**ARCHITECT'S ADDENDUM**

Addendum Number: 03

Transportation Center

Subject: Addendum No. 03 to the Construction Documents for the Fort Zumwalt School District Transportation Center

C9

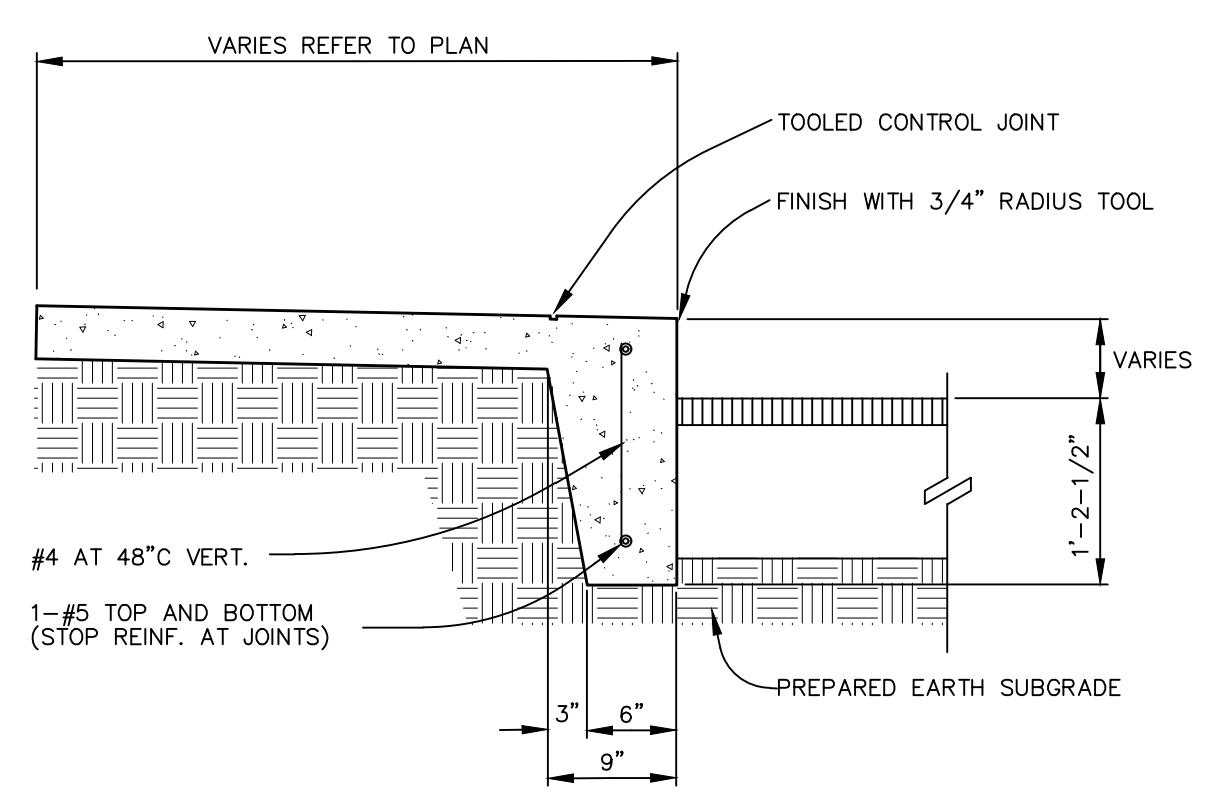
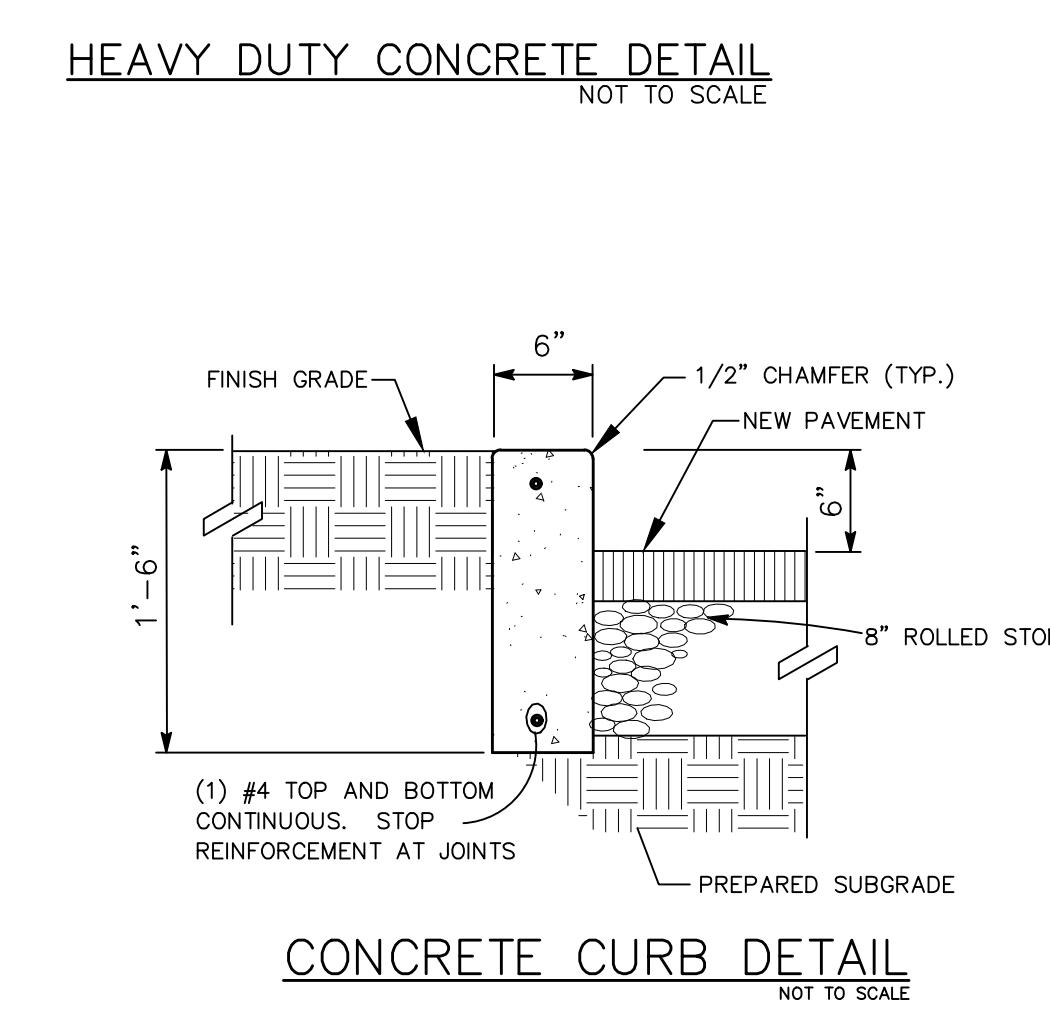
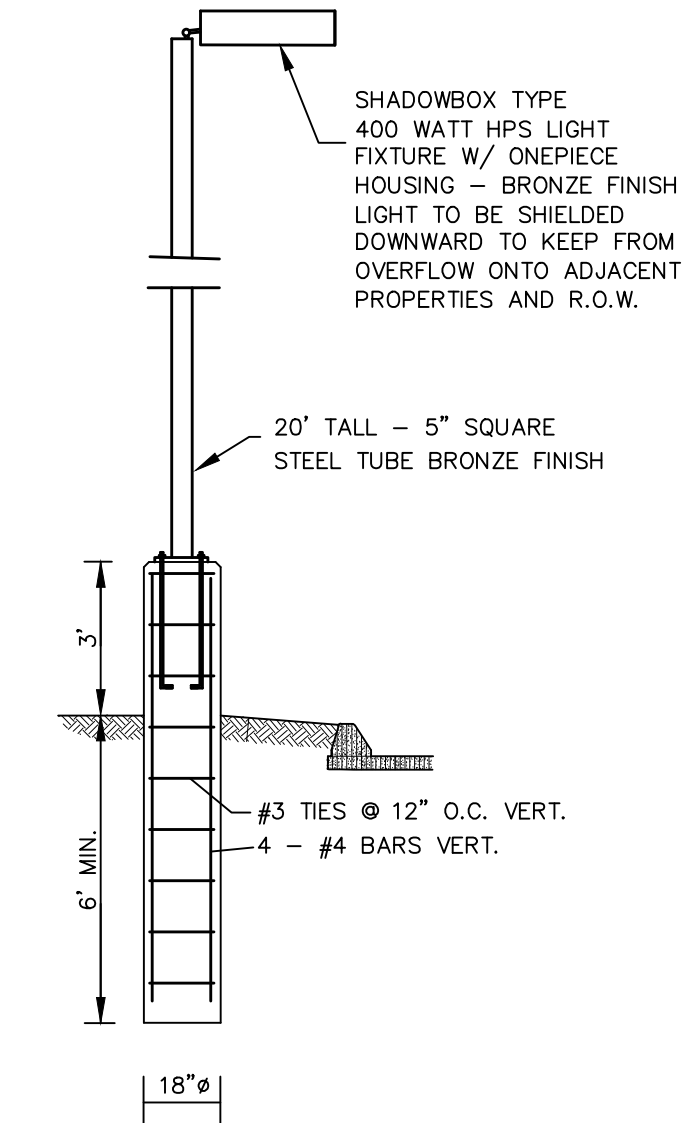
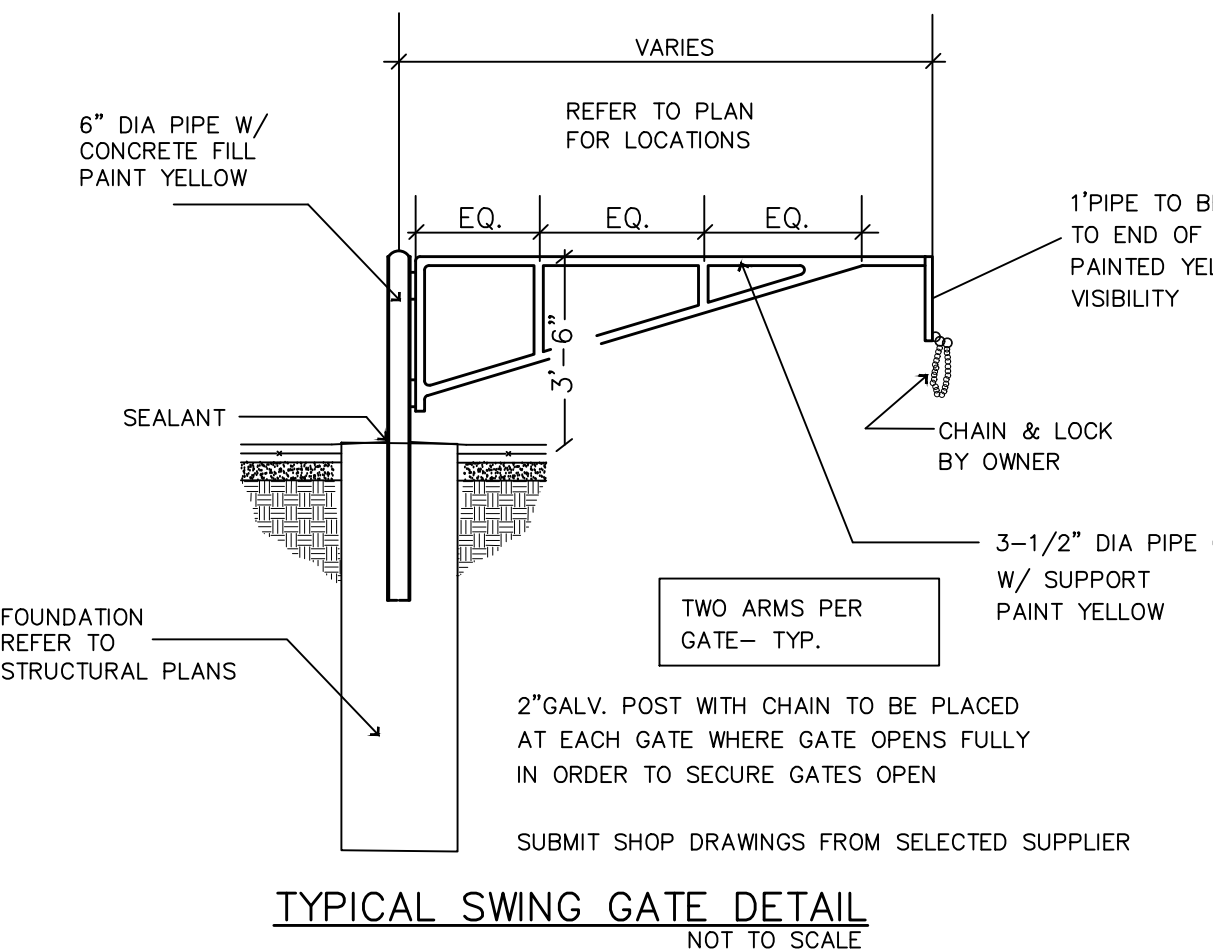
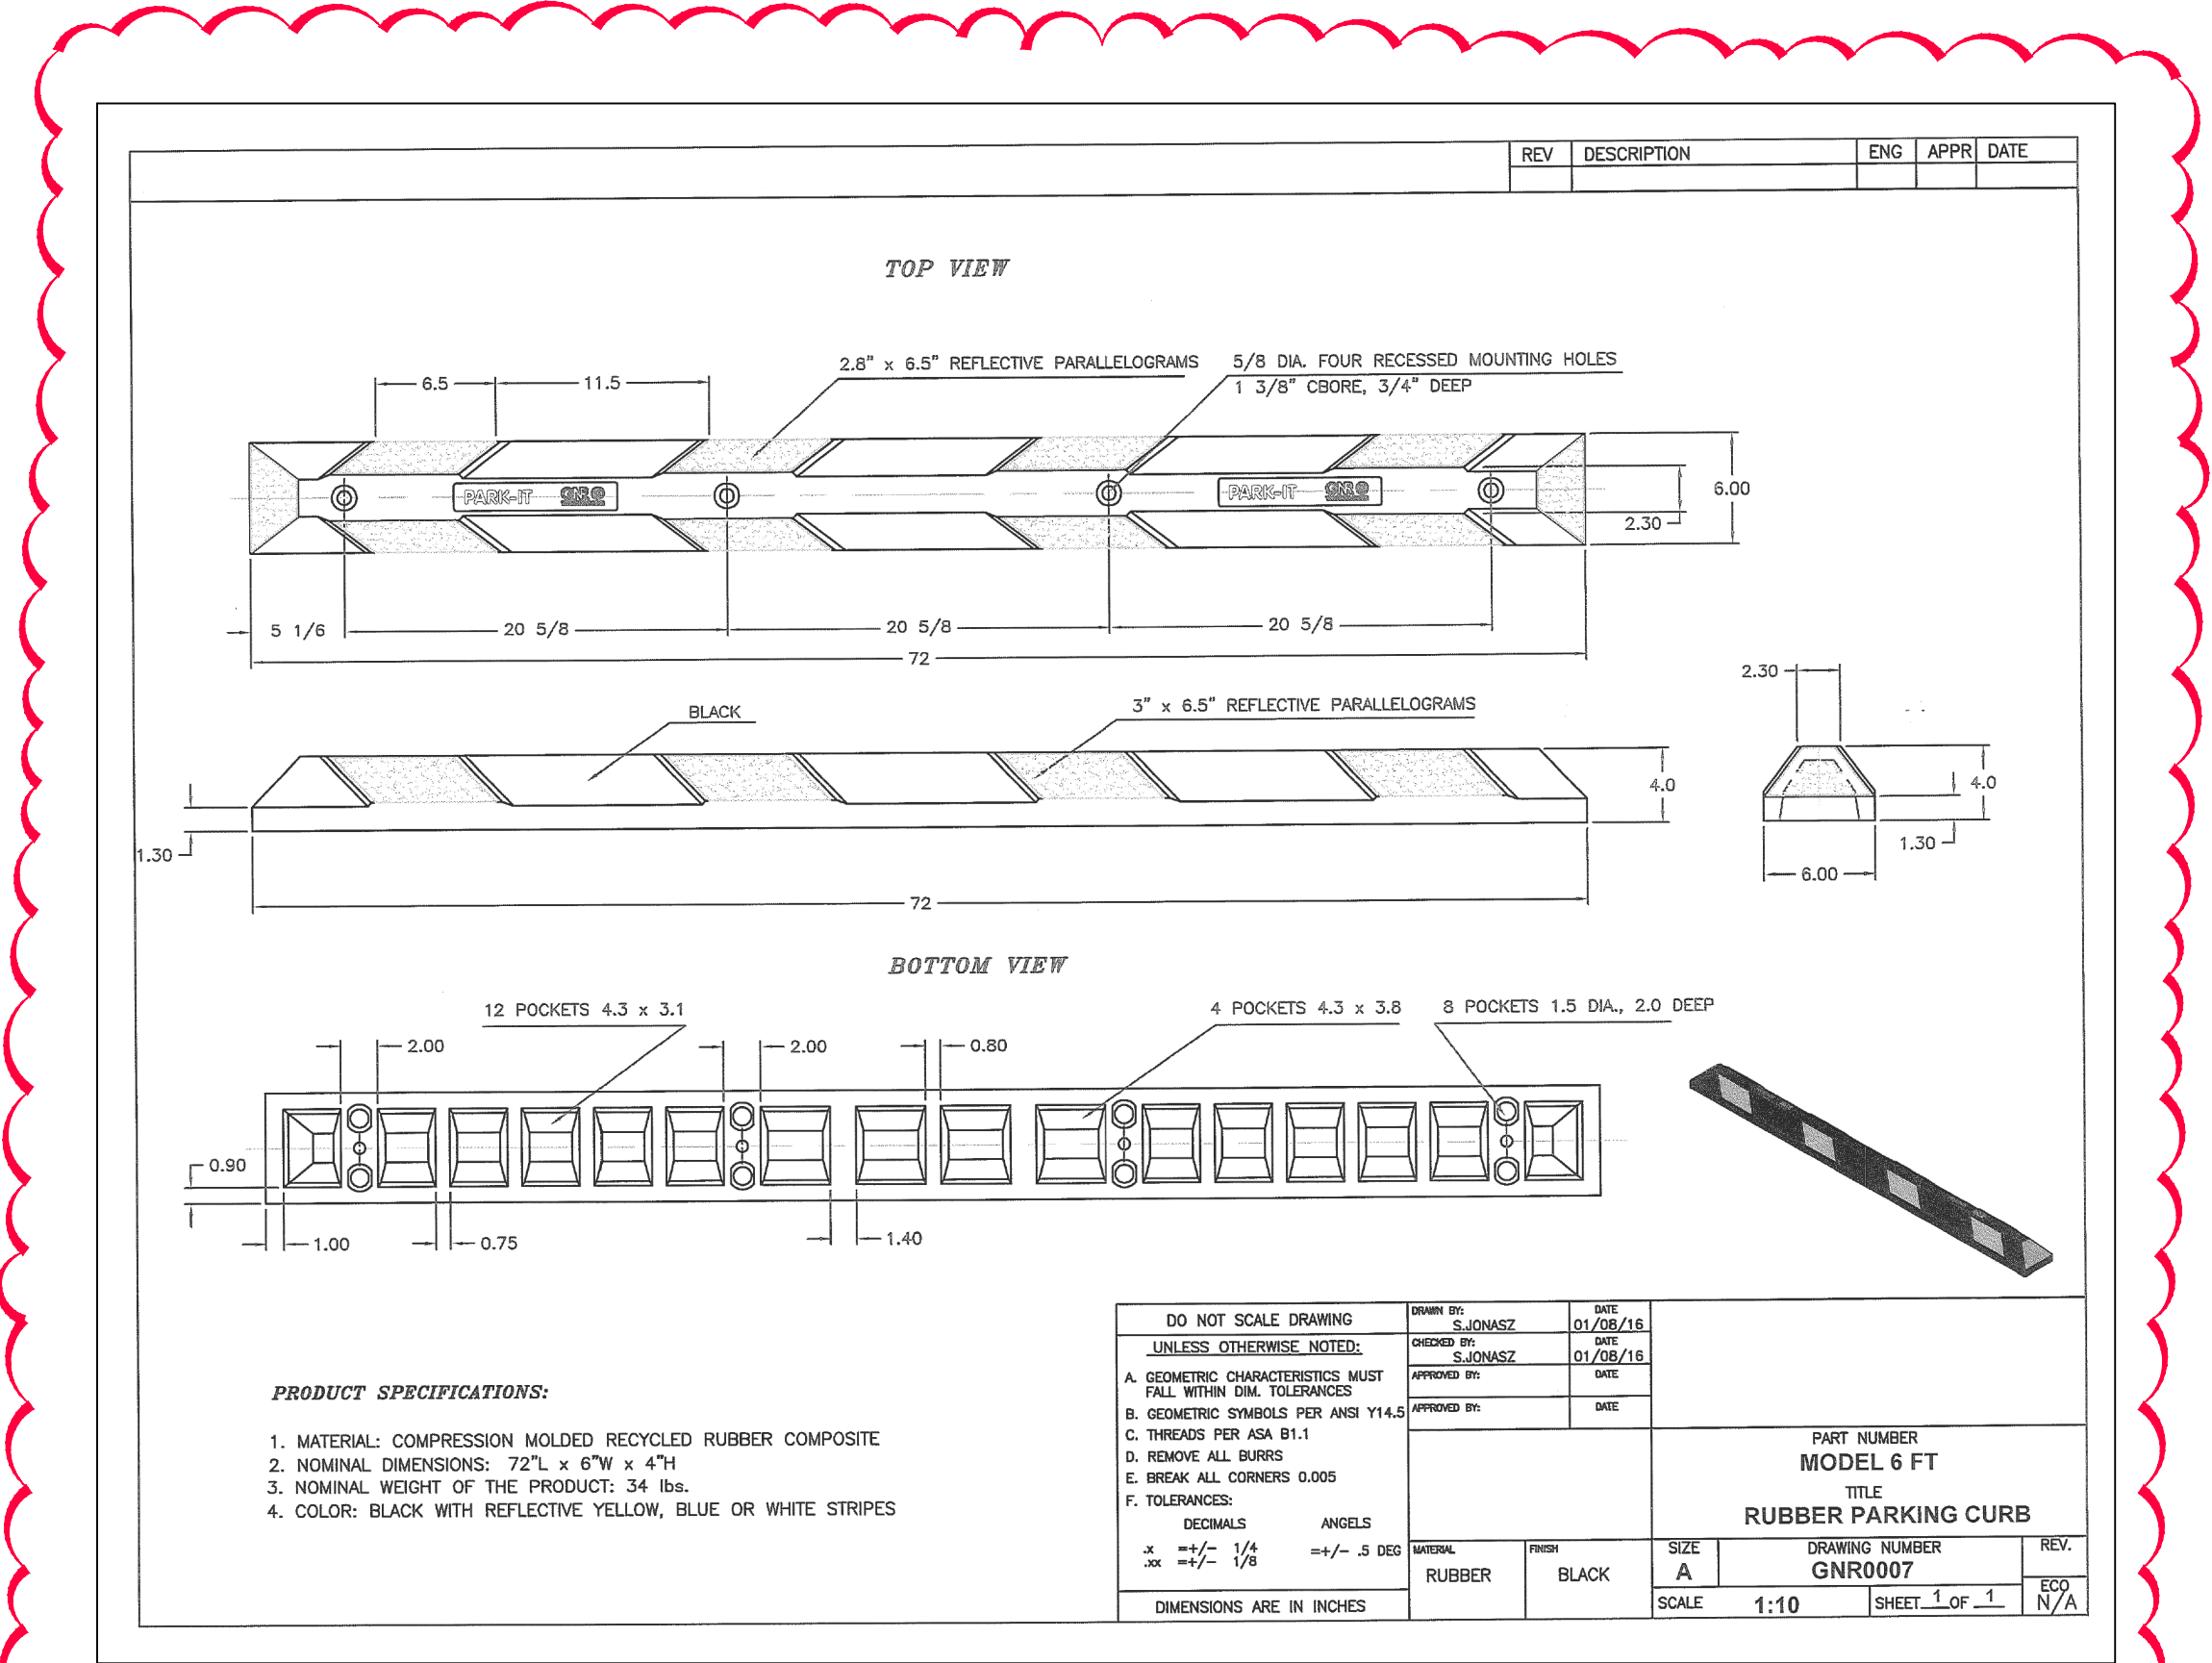
1. C3
  - a. Removed 3’ Rock Infiltration Strip callout
  - b. Added wheel stops to spaces along sidewalk
  - c. Modified number of curb cuts, added riprap at curb cuts
  - d. Added vertical curb near dumpster area
  - e. Revised callout of “Knox Box” at bus drive slide gate to “Gate Code Access Panel”
2. C5
  - a. Revised grading at Rain Garden Area A.
3. C9
  - a. Added wheel stop detail
4. C10
  - a. Revised Rain Garden details, added detail for Filtration Strip Seed Mix and Rain Garden Soil Mix
5. A2.01
  - a. Add bollards to south side of Service Bays 140 at overhead doors.
6. A3.01
  - a. Revise ceilings in rooms Staff Break 135 and Mechanic Break Room 150 to be ACT-1.
7. A5.01
  - a. Add bollards at overhead doors to South Building Elevation 3/A5.01.
8. A10.01
  - a. Revise Material General Finish Notes 6, 8, and 9 to correct paint colors.
